Air Resources Board

October 1, 2015

The California Air Resources Board (CARB) appreciates the opportunity to provide comments on the Notice of Proposed Rulemaking for the U.S. Environmental Protection Agency's (U.S. EPA) and the National Highway Traffic Safety Administration's (NHTSA) Greenhouse Gas Emissions and Fuel Efficiency Standards for Medium- and Heavy-Duty Engines and Vehicles - Phase 2, as published in the Federal Register on July 13, 2015.

CARB staff appreciates this opportunity to comment on U.S. Environmental Protection Agency's (U.S. EPA) and the National Highway Traffic Safety Administration's (NHTSA) proposed Phase 2 Heavy-Duty Program that establishes both GHG emission standards and fuel efficiency standards for new heavy-duty vehicles, the engines that power such motor vehicles, and trailers hauled by combination tractors.

Figure 1: Statewide On-Road GHG Emissions (Normalized to 2020 as a Baseline year) from Phase 2 Regulated Vehicles: without Regulation (Baseline including CARB Tractor-Trailer Regulation), with the Phase 1 Regulation, and with the Alternative 3 of Phase 2 Regulation

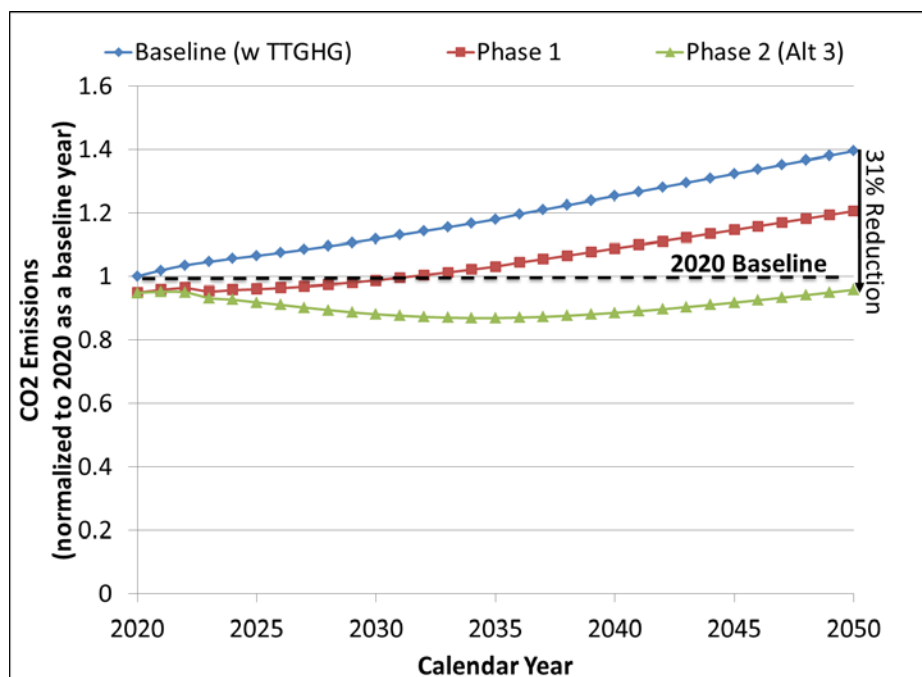
This comment provides an overview of the emissions benefits from the proposed regulation in California. Trucking operations in California differ substantially from the national average. Trucks that are operated primarily in California are retained by fleets

longer than the national average.⁸ In addition, the California trucking market is segmented, with national, regional and local fleets all competing in different segments of the goods movement economy; and hence it has a lower fraction of long-haul freight truck traffic as compared to national truck activity.⁹ This leads to a different vehicle fleet mix, vehicle age, and vehicle miles traveled (VMT) profiles than the national average. California's emissions model, EMFAC2014 (v1.0.7), reflects these California-specific factors, and is used to estimate the GHG emissions impact of the proposed rule as applied to medium and heavy-duty vehicles operating in California.

Using the model year (MY) specific percent reductions in CO₂ emission rates, staff assessed the emissions impact of the proposed regulation under both alternative 3 and 4 scenarios. Figure 1 shows the impact of the Phase 1 and Phase 2 (Alternative 3)

Figure 2: Statewide Cumulative On-Road CO₂ Emissions Benefit from the Alternative 3 and Alternative 4 of Phase 2 Regulation

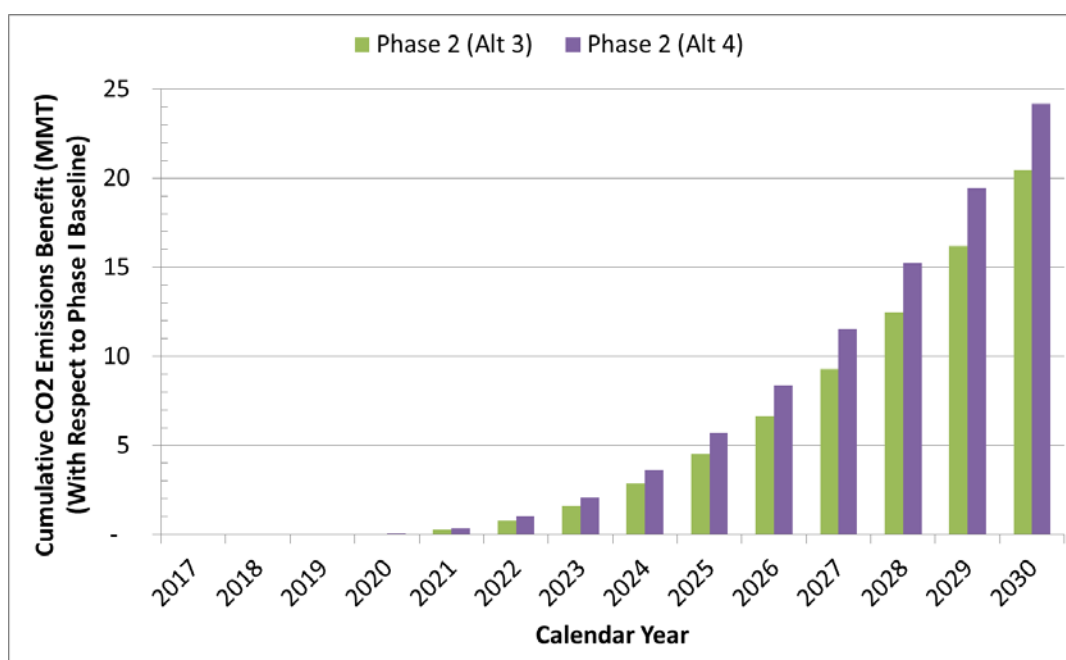
However, as explained in further detail below, CARB staff believes that U.S. EPA and NHTSA's proposed adoption of emission standards corresponding to "Alternative 3" does not adequately serve California's needs to reduce both greenhouse gas emissions and petroleum usage from heavy-duty vehicles, and therefore urges its federal partners to adopt the emission standards corresponding to the "Alternative 4" option.

regulations on GHG emissions from affected vehicles.¹⁰ Results show a combined reduction of ~31percent in GHG emissions by 2050. Furthermore, staff analysis shows that as compared to alternative 3, alternative 4 would achieve an additional 4 MMT cumulative benefit in CO₂ emissions by 2030 (Figure 2). If Alternative 4 is adopted, Phase 1 and 2 together would achieve approximately a 22 percent reduction in petroleum use from the medium- and heavy-duty sector in 2030. This reduction would be a first step towards reaching the California Governor’s goal of up to a 50 percent reduction in petroleum use by 2030. As shown in Figure 1, due to the relatively fast growth of freight activity in California and at California ports (which handle roughly 40 percent of the nation’s freight flow), GHG emissions from the regulated trucks will start increasing in 2035. Therefore, achieving California’s mid- and long-term climate change targets will require additional steps such as broader use of renewable fuels, increasing use of zero-emission technologies, and increasing operational efficiencies.

Figure 3: Simulated Drive Cycle Fuel Consumption Results

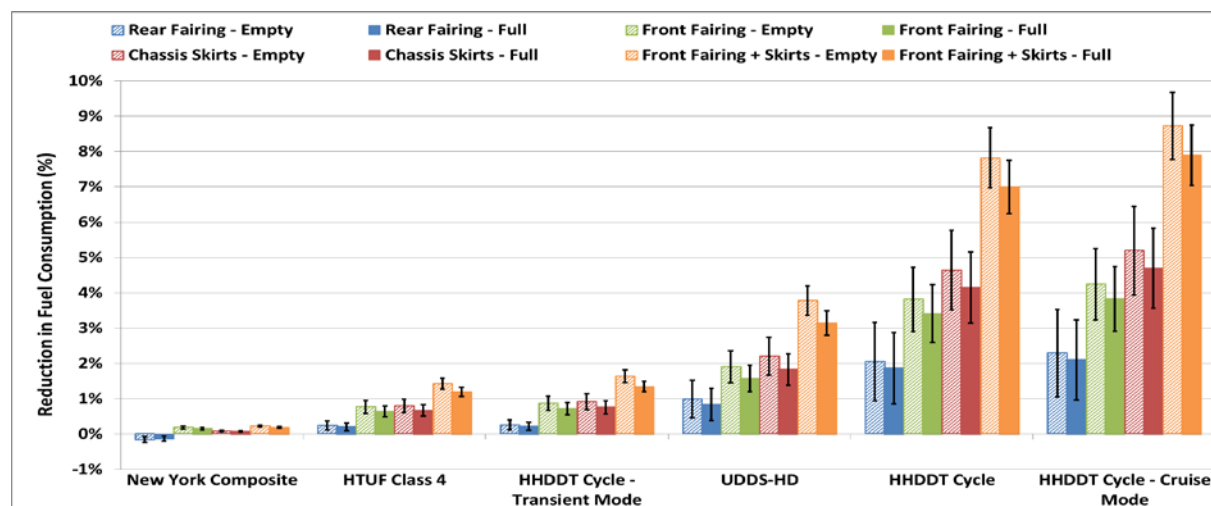
- Emission benefits up to 8 percent, depending on duty cycle: To determine the significance of their aerodynamic devices in real world operation of vocational vehicles, NREL applied their test results to a variety of test cycles commonly used for vocational vehicles. As shown in the chart below, for vocational cycles that contain a significant portion of high speed driving, the potential benefits of aerodynamic devices can be significant, up to 8 percent.

CARB staff appreciates that U.S. EPA and NHTSA referenced the data from CARB and NREL testing in the Phase 2 proposal. We encourage U.S. EPA and NHTSA to utilize other vocational aerodynamic data that they have obtained from other sources (e.g., Ford and Auto Research Center data), which will help particularly in the class 3 to 5 categories.

Figure 4: Comparison of Zero Yaw and Wind-Averaged Drag Results³⁵

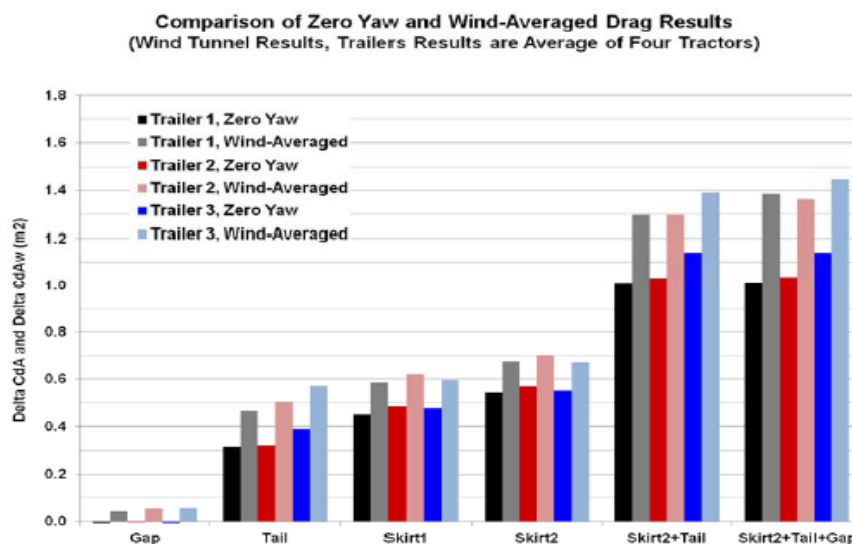
CARB staff is concerned that using only the delta of the zero-yaw values to determine the delta CdA for trailer aerodynamics may not accurately reflect the aerodynamic benefit from improved trailer aerodynamics. U.S. EPA and NHTSA recognize that the benefits of aerodynamic devices for trailers can be better seen when measured considering multiple yaw angles. This is illustrated in Figure 22 from the RIA (shown below - Figure 4). The wind- average results were calculated at 55 mph vehicle speeds, consistent with the procedures in 40 CFR 1037.810. The wind-averaged analysis consistently results in a larger improvement (i.e., delta CdA) than the zero-yaw results.

assume that tractor-trailers always travel when winds are coming straight at the vehicle. If the test method does not reflect wind-averaged drag, manufacturers run the danger of developing aerodynamic products that result in meeting standards that result in minimal or no benefit in real-world conditions. The opposite could also be true, where a technology that shows minimal benefit under zero yaw analysis can show measurable benefit when wind-averaging over multiple yaw angles are considered. This is illustrated in Figure 22 (shown below - Figure 4) for the gap fairing technology tested.

Figure 6: Class 8 Truck Fuel Economy as a Function of Speed and Tractor-Trailer Tire Combination and Percentage of Total Distance Traveled as a Function of Speed⁶¹

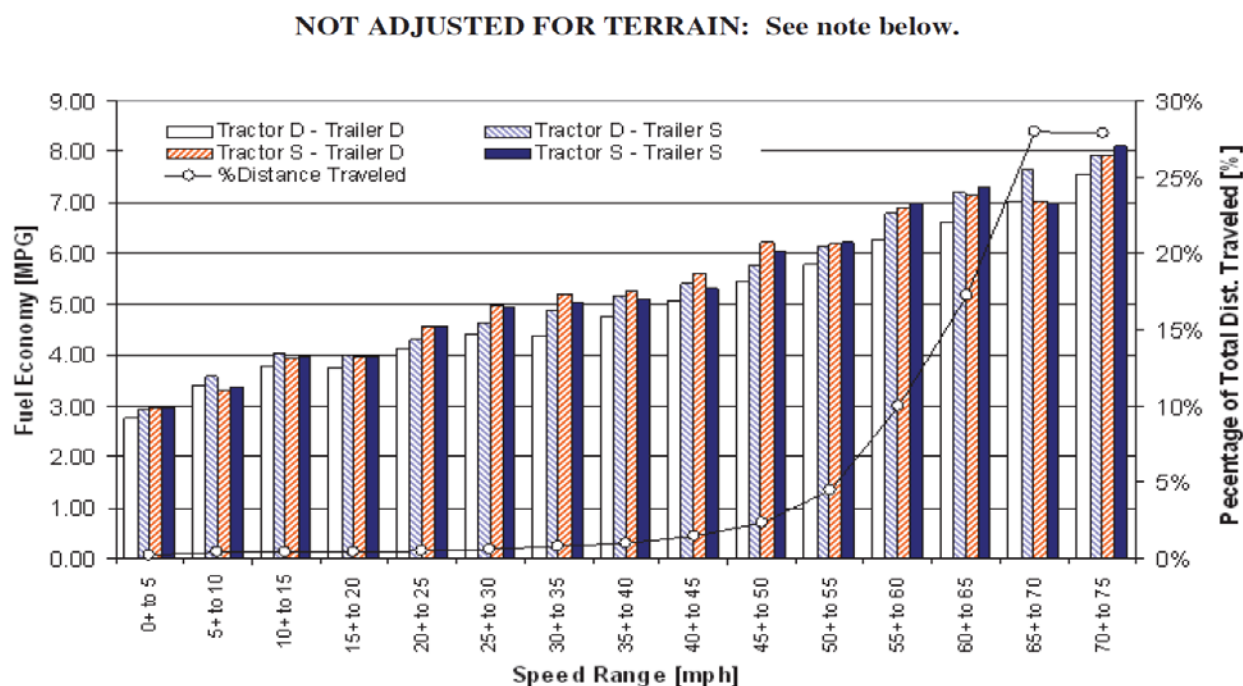
CARB staff recommends not giving any credit for VSLs at this time because available data do not fully support whether VSLs result in real-world fuel consumption and CO₂ reductions. In addition to the concerns regarding possible tampering of VSLs when in use, which the NPRM mentions, the data are still inconclusive as to whether VSLs can provide real-world fuel benefits, especially for modern trucks.⁶⁰ In fact, CO₂ emissions were shown to decrease as vehicles' speed increase (improved fuel economy at higher speeds) in Oak Ridge National Laboratory's (ORNL) Transportation Energy Data Book (Table 5.11, Fuel Economy for Class 8 Trucks as a Function of Speed and Tractor-Trailer Tire Combination, and Figure 5.3 (shown below – Figure 6), Class 8 Trucks Fuel Economy as a Function of Speed and Tractor-Trailer Tire Combination and Percentage of Total Distance Traveled as a Function of Speed, available at <http://cta.ornl.gov/data/chapter5.shtml>).
